REMEDATION SYSTEM EVALUATION

RISDON CORPORATION
DANBURY, CONNECTICUT

Report of the Remediation System Evaluation,
Site Visit Conducted at the Risdon Corporation Site
January 15, 2003

EPA 542-F-04-027
September 2004
www.epa.gov/tio
clu-in.org/optimization

FIGURE 1-3. EXTENT OF VOC CONTAMINATION BASED ON THE SEPTEMBER 2001 SAMPLING EVENT AND THE 2002 OFF-PROPERTY SOIL VAPOR AND GROUNDWATER SAMPLING REPORT. THE ORIENTATION OF CROSS-SECTION A-A' IN FIGURE 1-2 IS DEPICTED.

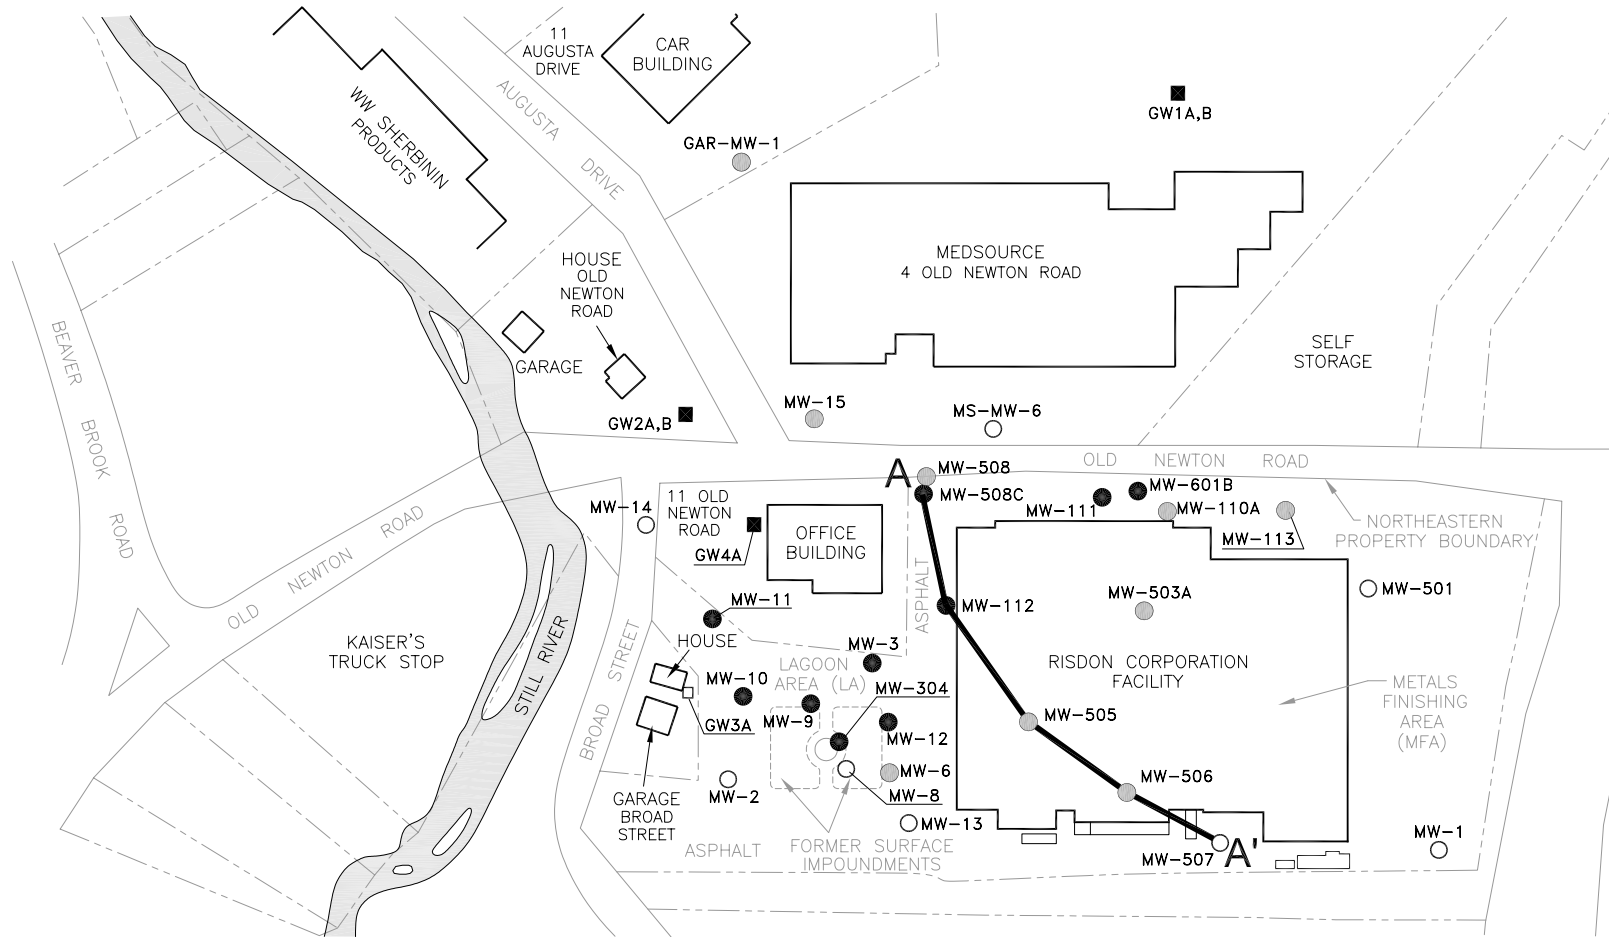
information with regard to the extent of the bedrock contamination found in MW-508C. The majority of the existing offsite monitoring wells are depicted in Figure 1-3.

FIGURE 4-1. POTENTIOMETRIC SURFACE MAP PROVIDED IN THE JANUARY 2003 GROUNDWATER MONITORING REPORT.

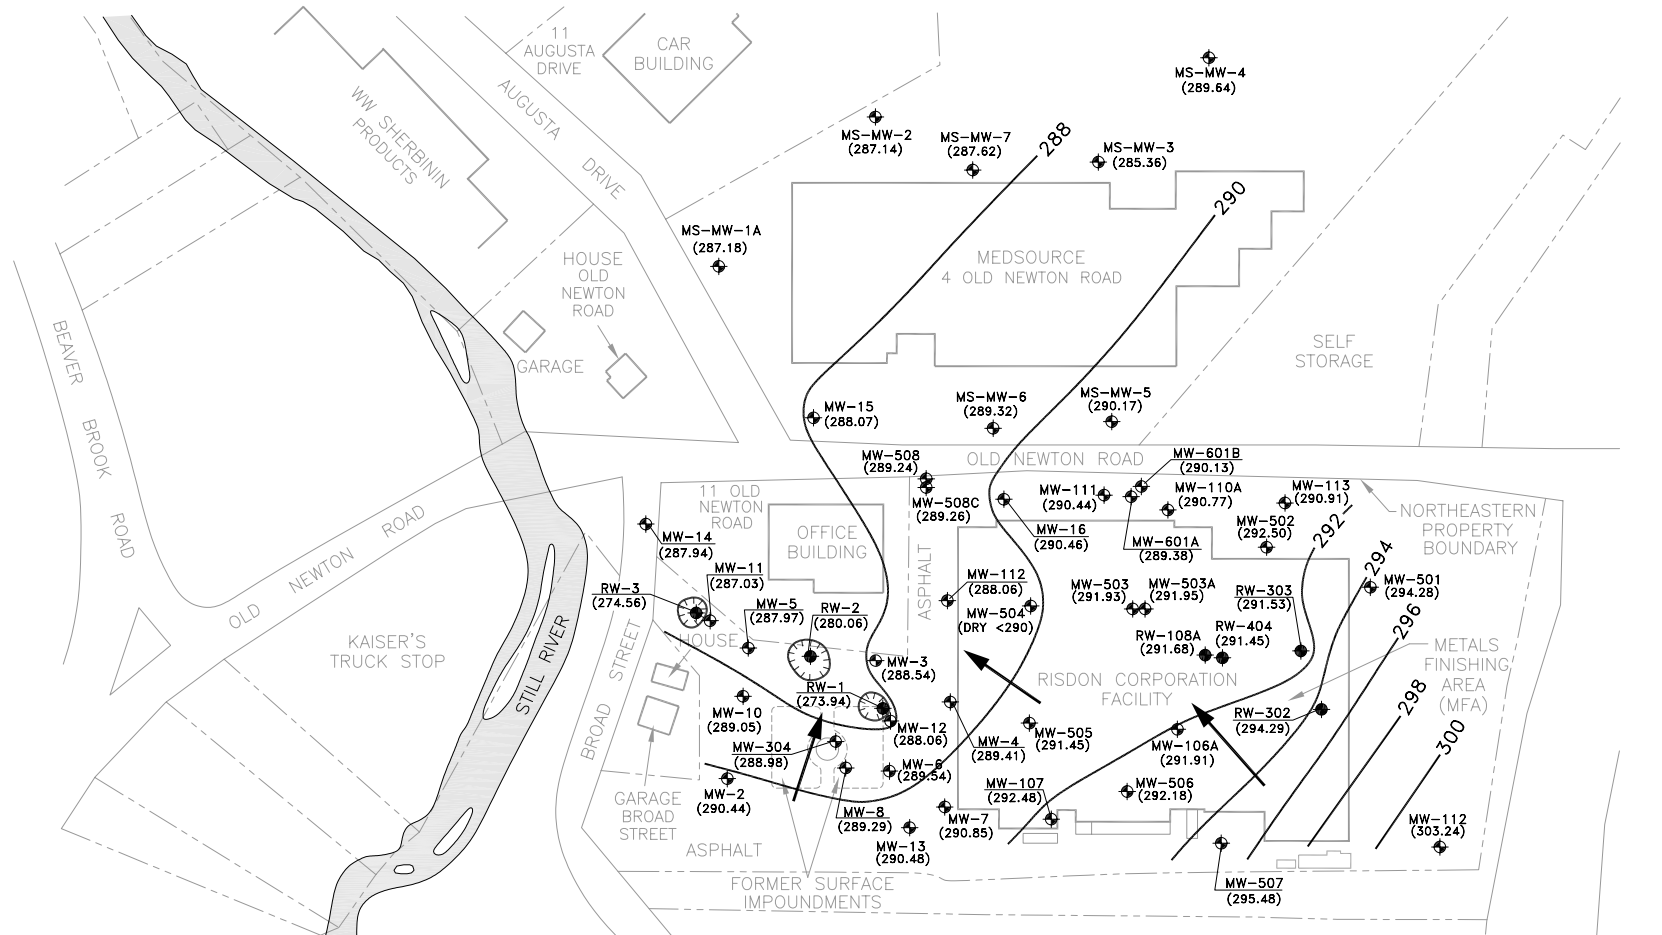
Ground water levels are collected and interpreted with each monitoring event. The potentiometric surface map presented in the January 2003 Ground Water Monitoring Report is included as Figure 4-1. It shows what appears to be influence of both P&T systems on the regional ground water flow. For example, the map shows that the regional gradient flattens in the MFA where extraction is occurring and cones of depression near each of the LA extraction wells. The contours, however, are influenced by the water elevations measured from operating extraction wells. Because extraction wells are subject to well losses and have very localized drawdown due to pumping, water levels from these wells are not necessarily indicative of the water level in the surrounding formation. As a result, if other water level measurements are not made in the area, some of the contours may show excessive influence due to pumping and perhaps an overestimated interpretation of plume capture. Specific examples of where the contours may overestimate the influence of pumping are as follows:

The monitoring report also does not provide the extraction rates for the various wells. Although extraction rates for the LA wells were originally 3 gpm each for a total of 9 gpm, the pumping has likely changed. In 1996, the total extraction rate was estimated at 3.5 gpm, and during the RSE site visit the flow totalizers for these wells revealed a total pumping rate of approximately 4.5 gpm, with RW-3 not operating. To better resolve the influence of pumping on the regional hydraulic gradient, the pumping rates should be provided along with the potentiometric surface maps, when possible.

FIGURE 6-1. RECOMMENDED LOCATIONS FOR ADDITIONAL EXTRACTION WELLS.

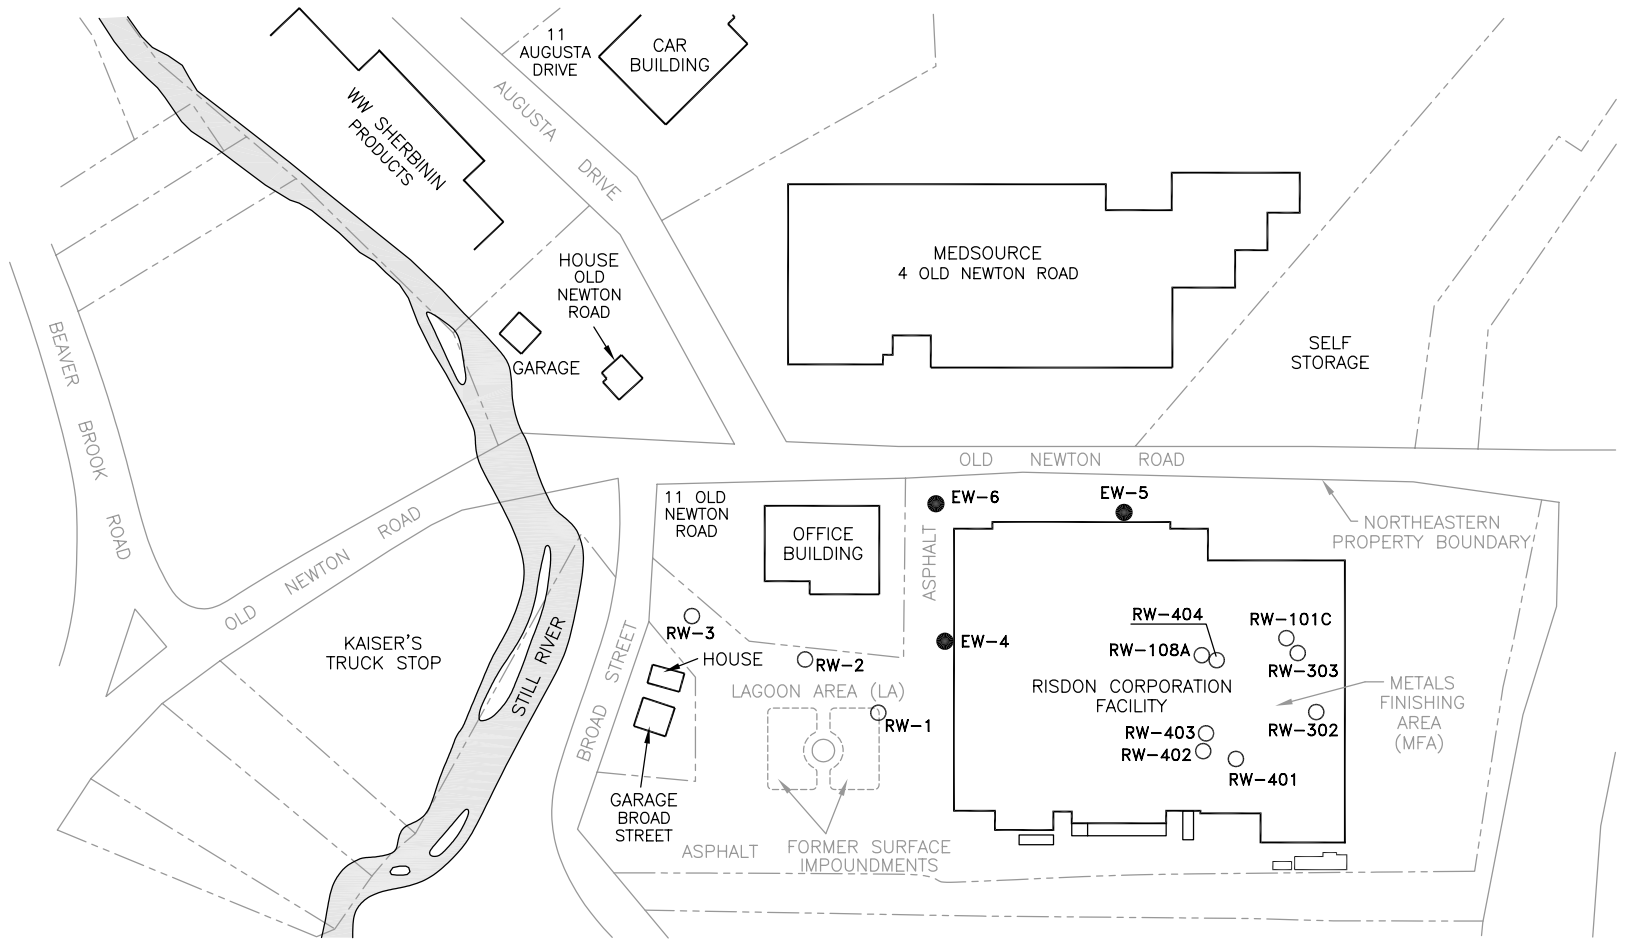
- It should work in concert with pumping from the LA to prevent offsite migration of contamination in both the overburden and the bedrock (i.e., stabilize the site).
- It should provide a zone of capture that, if possible, does not include receptors. That is, the extraction wells should be located such that contamination is not pulled near potential receptors at levels that pose an unacceptable risk.

Submersible pumps should be used at the new wells because they allow for drawdown beyond ~27 feet (~80% of a perfect vacuum), which is the maximum the aboveground pumps can draw. The extra drawdown may or may not be necessary but in case it is, submersible pumps can provide it for a cost similar to aboveground pumps. The facility might also potentially save cost on smaller vault construction by using submersible pumps.
